Groundwater Application Review Summary Form

Application # G- 18635

MEMO

PUBLIC INTEREST REVIEW FOR GROUNDWATER APPLICATIONS

Figure 1. Water Availability Tables

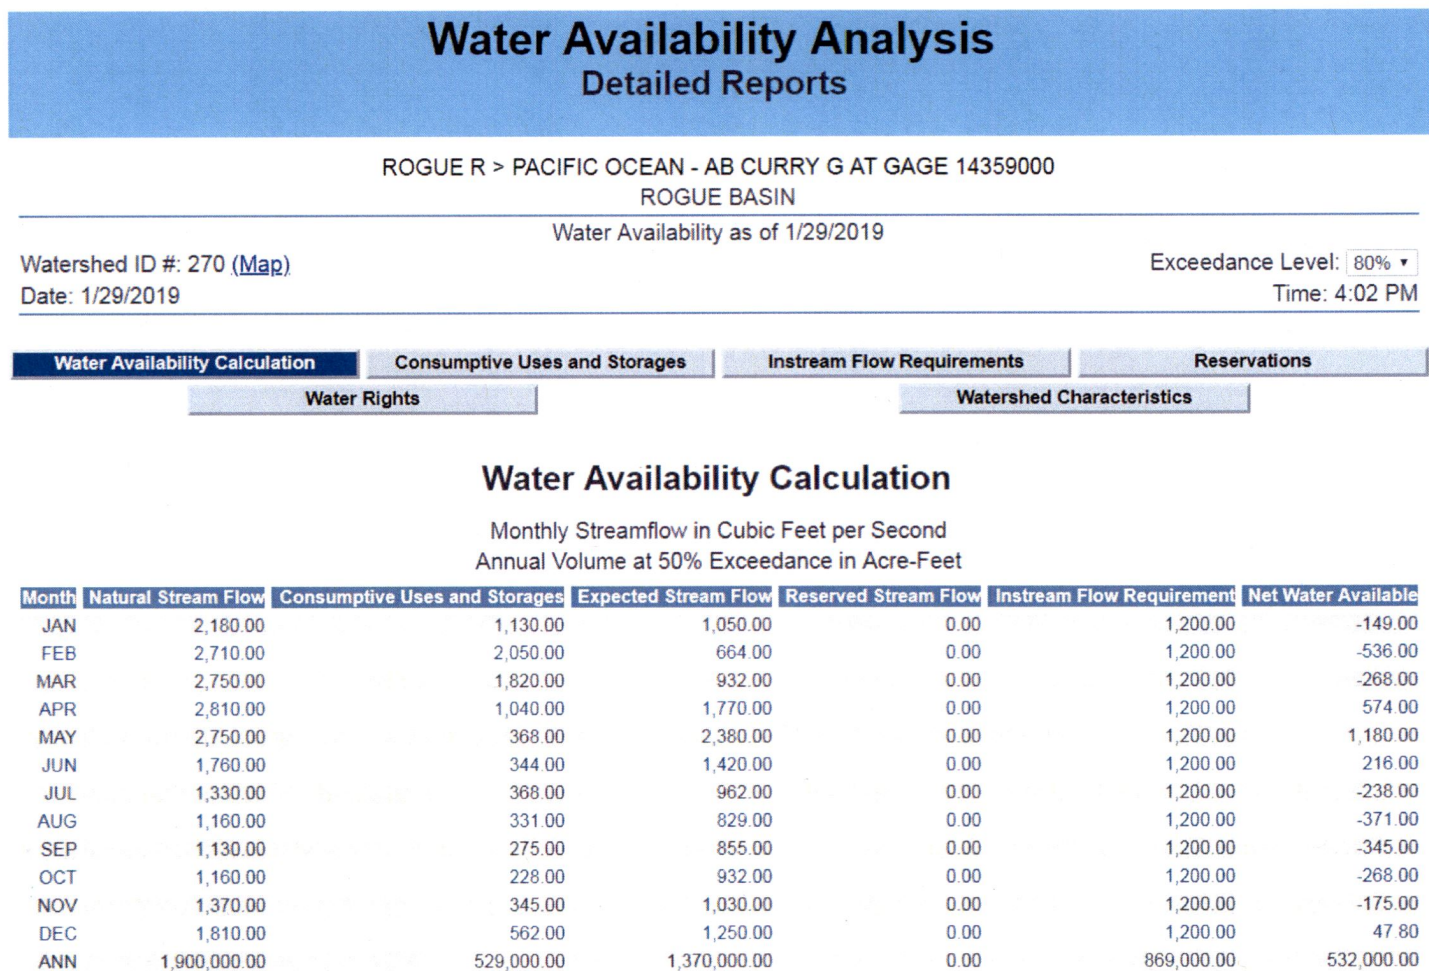
The proposed aquifer is found to be hydraulically connected to both the Rogue River and Constance Creek, which are in the same WAB. The table above demonstrates that 1% of expected natural streamflow is greater than the maximum requested rate so that 100% stream depletion would not trigger the assumption of PSI as per OAR 690-009. Stream depletion is not estimated here for this reason.
